Gilchrist/Crescent Public Workshop  
 Gilchrist Restaurant Banquet Room  
 Meeting Notes  
 October 11, 2007

**Options for sidewalks in Crescent** (see diagrams at end of notes)

<b>OREGON DEPARTMENT OF TRANSPORTATION</b>	
<b>kptf</b> Consulting Engineers <small>2000 NE Oregon Street, Suite 200        Corvallis, Oregon 97331        Phone: 541-325-2200        Fax: 541-325-2201        Email: kptf@kptf.com</small>	
<b>US97: OR31 HWY JCT - SCL CRESCENT</b> THE DALLES-CALIFORNIA DESCHUTES & KLAMATH COUNTIES	
Design Team Leader - T. SHELL Designed By - F. MADDOX / M. BEYER Drafted By - B. CADU	
<b>TYPICAL SECTIONS</b> <b>MP 185.10 TO 186.85</b>	SHEET NO. <b>1</b>

#### Poor Pavement north of Gilchrist and south of the bridge

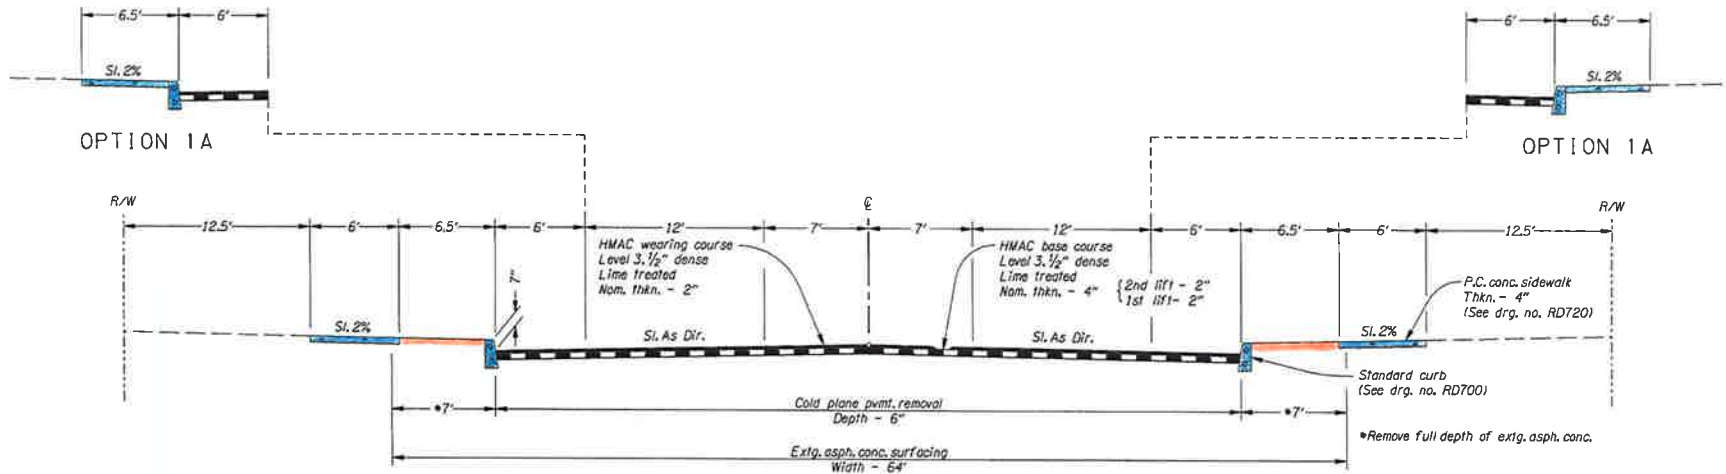
- This section of pavement is constantly falling apart and needing repair. Can a French drain system be installed to take care of the water issue? ODOT has noted this problem and is working on a solution.

OPTION 2

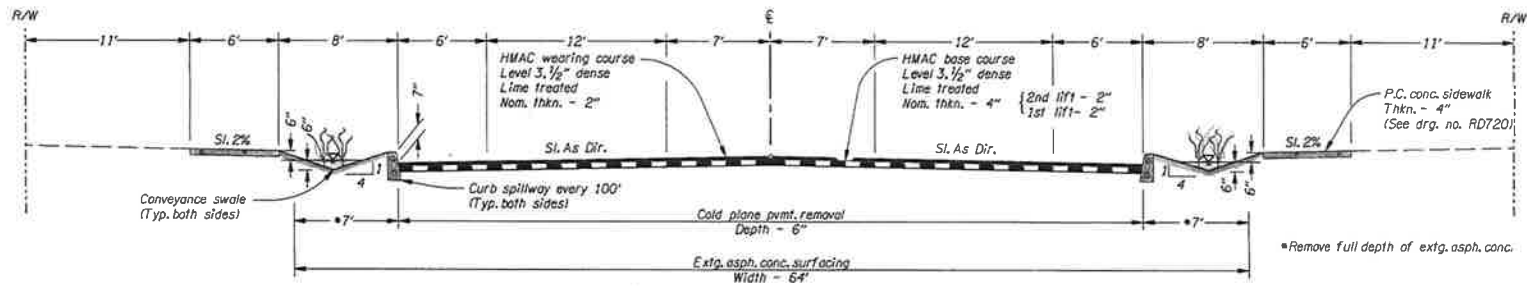
Pros	Cons
Option 1	Doesn't change area in front of businesses (perceived right of way)	Have to rebuild storm water system
		Maintenance of the 6.5 foot open space – not landscaped
		Not visually appealing
		Snow removal from the highway could run onto the sidewalk.
Option 2	Sidewalk is separated from the highway	Area in front of businesses/residences is smallest with this option but doesn't require right of way.
	Do not have to rebuild storm water system	
	Visually appealing	
Option 3	More separation of the sidewalk and highway than option 2	Area in front of businesses/residences is smallest with this option but doesn't require right of way.
	Flat bottom ditch is easier to maintain than option 2 (v ditch)	
	Flat bottom ditch has the ability to hold more water than option 2 (v ditch)	
	Do not have to rebuild the storm water system	
	Visually appealing

**Option 2:** This option was *dismissed* because the landscaped ditch in Option 3 provided more water retention and easier maintenance.

OPTION 3

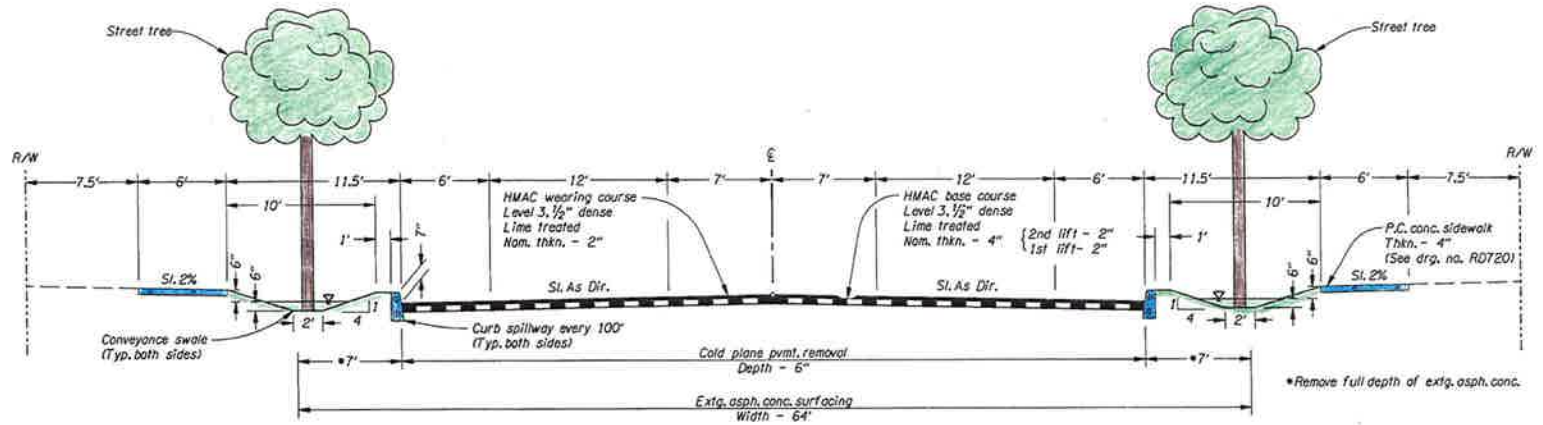
**Option 3:** Selected as the *preferred* option based on the comments listed above and in the table.
